Product Change Notice

The JENSEN® JE3217 32" LED AC Television is replacing the JENSEN® JE3215 32" LED AC Television.

Cabinet Tooling Change

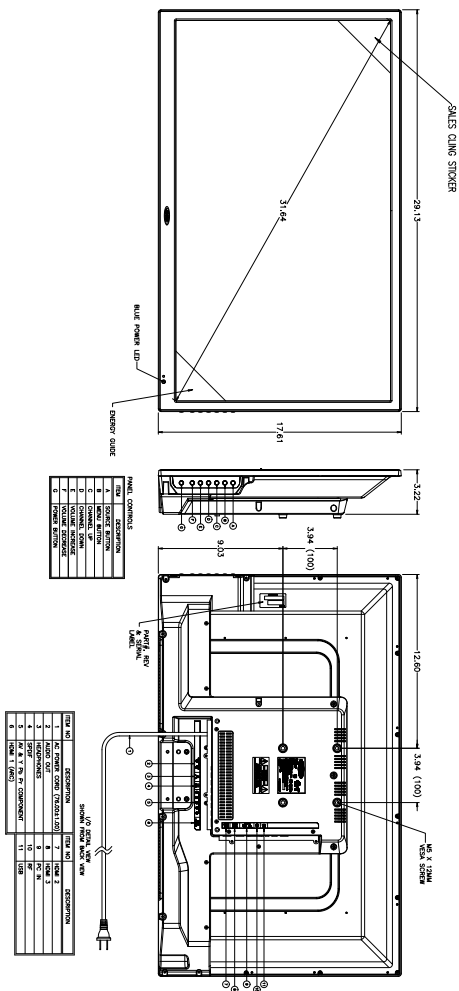
- New size: 28.8" x 17.4" x 3.2"
- Button location will change to bottom right side of TV
- IR window location will change to the lower left side of front housing.
